## **REPORT**

### **Based on the results of the review of the design and cost estimate documentation**

**Project:** “New construction of a civil defense shelter—a dual-purpose structure with protective properties as a radiation shelter for the needs of the S.F. Rusova Oleshnya Lyceum of the Dobryanska Village Council, located at: 4-A Shkilna St., Oleshnya village, Chernihiv District, Chernihiv Region.”

Stage “P” (Project)

### Sheet AR-11

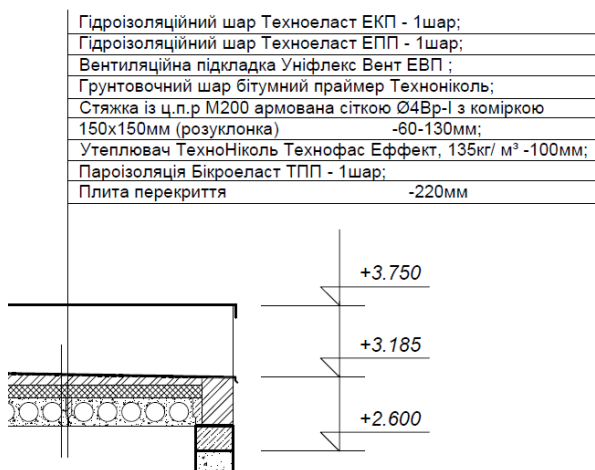
35. Add specifications for the infill of window and door openings marked on the plan, sections, and elevations in accordance with Section 5.3.6 of DSTU 9243.7:2023, using Form I.1 or I.2 of Appendix I of DSTU 9243.4. Provide a reference to the sheet containing the room finishing schedule and floor details.

36. On the plan along axes B and 2, the openings for ventilation grilles shown in drawings OV1-3 are not indicated.

37. Along axis 1, the door type is DMP. Exterior doors must be metal, but not fire-rated.

38. The plan does not show the 1000x1000x1500(h) drainage pit as per the TM drawings.

## ***Sheet AR-14***

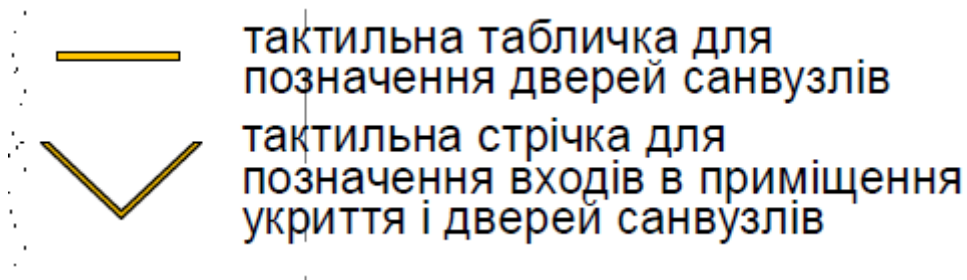
43.4 Justify the installation of a warning (or informational) traffic sign in front of a 1300 mm passage.

43.5 Guide rail for TS, Section 8.2.11 of DBN V.2.2.40:2018, Amendment 2. Special directional TS must be 0.3 m wide (0.4 m is permitted) and consist of raised longitudinal ridges or ribs parallel to each other and to the direction of travel. The design shows two strips of unknown width.

Sheet KB-03

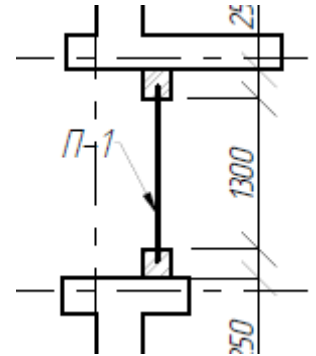
4.2 The provided list does not contain complete and clear information.

- P-1 is listed as both the grade and the position. This is incorrect: The grade of the lintel is specified according to DSTU B V.2.6-55:2008, while the position of the lintel is indicated on the plan as P-1...P-3.
- Does the specified quantity refer to the grade or the position?

- Please justify the column “NUMBER OF BRIDGES” for the roof?
- There is no data regarding the standards for lintels (according to DSTU B V.2.6-55:2008)
- Unit weight data in kg is missing (required for cost estimate documentation)

In accordance with Section 6.3.8 of DSTU 9243.7:2023, on the lintel layout diagram, complete the lintel schedule in accordance with Form 4 and the lintel element specification in accordance with Form 5. Examples of how to complete the lintel schedule and lintel element specification are provided in Appendix B.

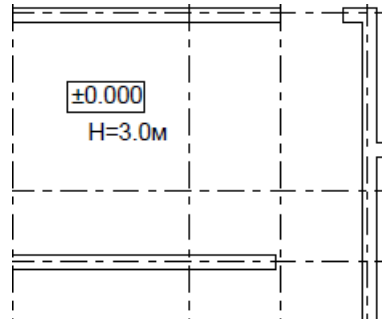
4.3 Wall thickness dimensions are missing. According to AR-04, the thickness is 250 mm. Indicate all wall thicknesses on the masonry plan.

5. On the structural plan, the room height is 3.0 m, which does not correspond to the 2.5 m dimensions shown on this sheet.

#### ***Sheet KB-08***

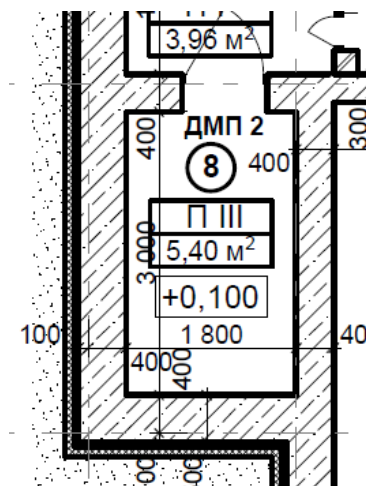
21. The reinforcement of wall corner joints with horizontal reinforcement is not shown. Missing: formwork plan, slab reinforcement plans. Provide a list of reinforcement for walls and floor slabs.

### ***Sheet KB-13***

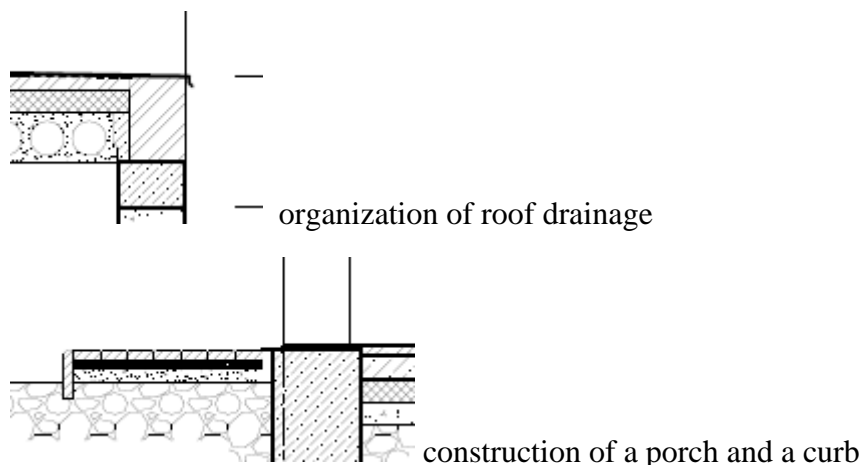
24. The foundation plan for the boiler room does not show a 1000x1000x1500(h) drainage pit as per the TM drawings.
25. The weight of A500C rebar for the strip foundation is specified as 20 tons in the specifications, which is clearly an exaggeration. The rebar consumption for the strip foundation is no more than 300 kg.

#### 2-2

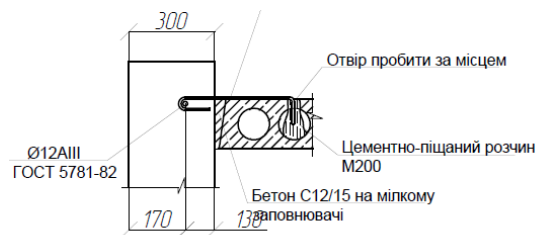
34.2 At node 2 and its section 2-2, indicate the depth of support for the roof slab. According to section 2-2, the support is shown on brickwork (as indicated by the hatching since there are no labels), but on other sections and nodes (other sheets), a monolithic belt is shown.

34.3 Detail 1 and its section 1-1. In section 1-1, the construction of the 300 mm thick slab into which the reinforcement is embedded is unclear.

### **Sheet KB-18**

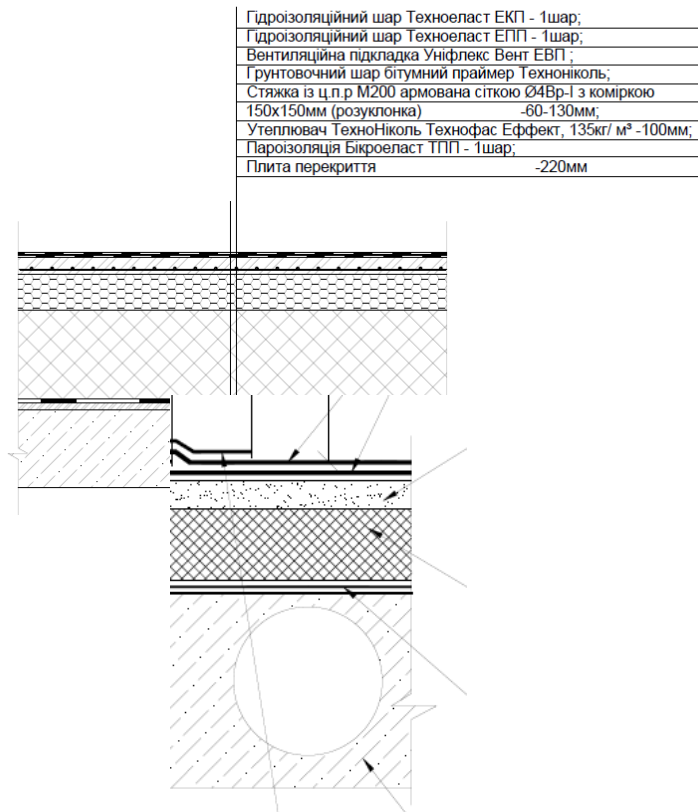
35 The scope of work for roof installation is missing (include all materials for installing the parapet, the connection to the parapet, and the installation of the edge element for roof drainage)

34.1 This cross-section shows two types of insulation (hatched), but the list includes only one with a thickness of 100 mm.

Joint at KB-18.

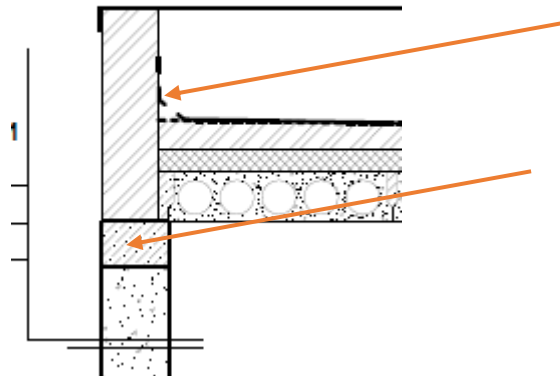
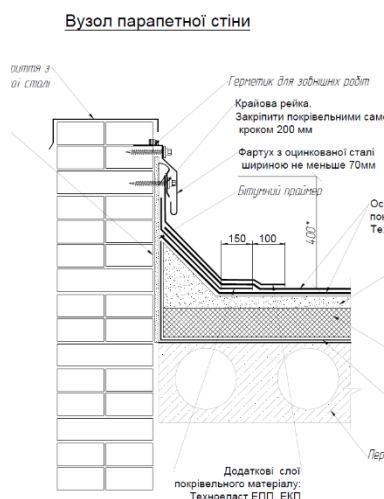
34.3 Discrepancy between the node and the cross-section

- No monolithic belt, hatching does not match, support of the floor slab is unclear.
- 36 On the roof plan along axis 2, there must be a roof overhang in the absence of organized drainage. According to Section 10.1 of DBN V.2.6-220:2017 “Roofing of Buildings and Structures,” unorganized drainage should be provided by equipping the roof with eaves of the required dimensions and by mandatorily installing a drainage area around the building with a width of at least 1 m.
